Subject: Moruya East Village – Issues of Concern by Department of Planning

I understand that you wish me to provide a response to Issues 16 and 17 in Attachment B of the DoP letter dated 21 July 2008 and Issue 1 in Attachment 1 to the DoP letter dated 13 June 2008.

20080911 #21935 Moruya East Village - E&P Response to DoP and Public Submissions.doc

Figure 1
Sensitivity of 1% AEP Flood Level at
Moruya East Village to Increased Rainfall

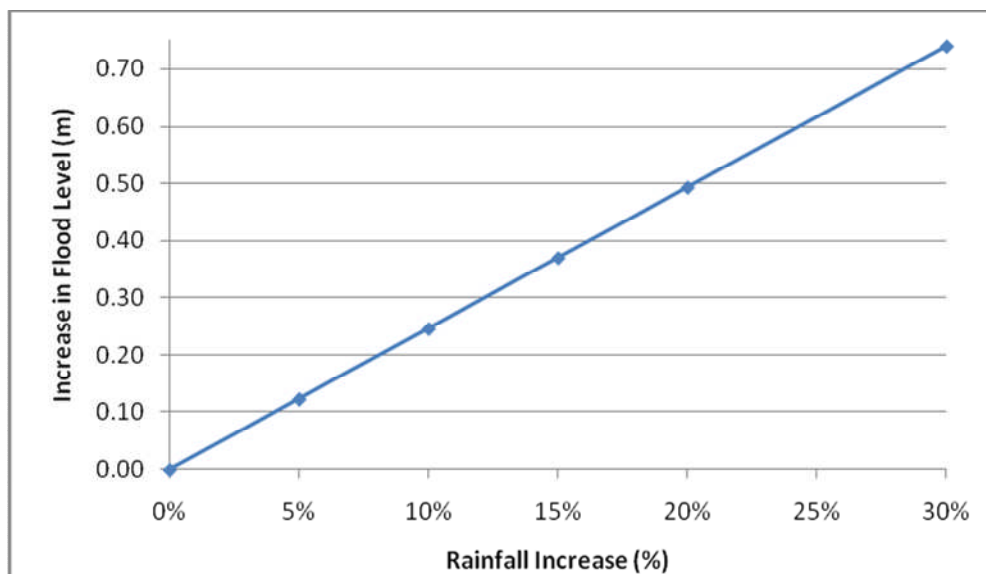
"Inadequate Assessment has been made with regard to sensitivity analysis for climate change on flood levels."

The hydrologic analysis in the *Moruya River Flood Study* established that the 1% AEP “design” catchment rainfall together with an areal reduction factor of 0.94 (as recommended in *Australian Rainfall and Runoff*) led to a peak flood level at Moruya Bridge that was 0.3 m lower than that estimated from flood frequency analysis. In order to achieve a flood level equal to that predicted by the flood frequency analysis it was necessary to increase rainfall by 10% and eliminate the areal reduction factor; a total increase of 11%.

Figure 1 shows the sensitivity of the 1% AEP flood level at the Moruya East Village site based on:

- An increase in rainfall of 11% leading to a rise in flood level of 0.3 m at Moruya Bridge,
- The flood levels for various AEP floods set out in Table 8 of the *Flood Study*, and
- Flows for various AEP floods shown in Figure 44 of the *Floodplain Management Study* (Patterson Britton, 1999).

Figure4.2
MUSIC Model Layout

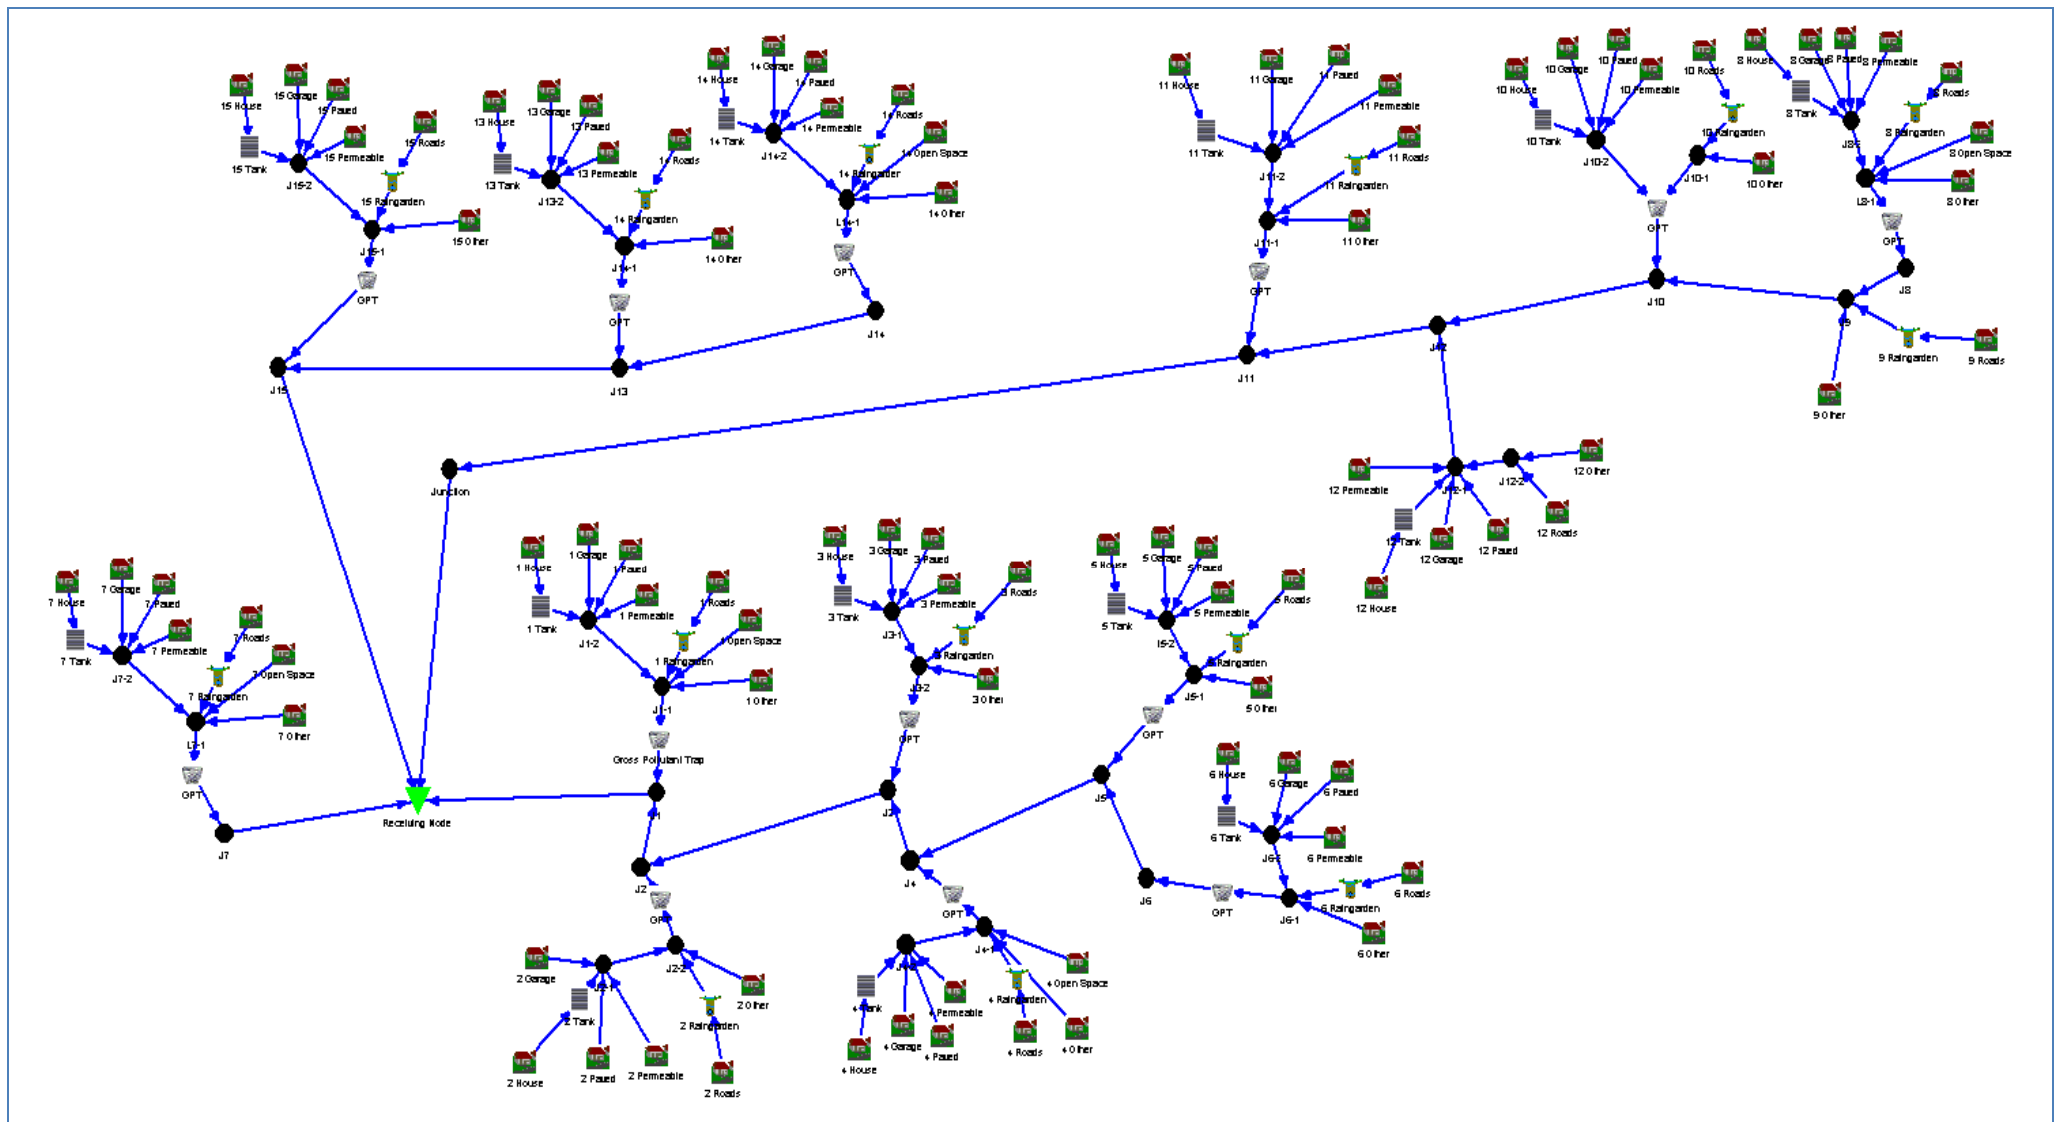
Because of the size of the MUSIC model for the post-development conditions and the limitations of the available computing resources at the time the analysis was undertaken, the pos-development stormwater quality model was split into two sections comprising:

- a) Sub-catchments 1-7 and 13-15;
- b) Sub-catchments 8-12.

Unfortunately, the schematic diagram and results for part b) were inadvertently omitted from the original report. An updated version of Figure 4.2, which includes all sub-catchments, is appended to this letter. An updated version of Table 4.5 is included below.
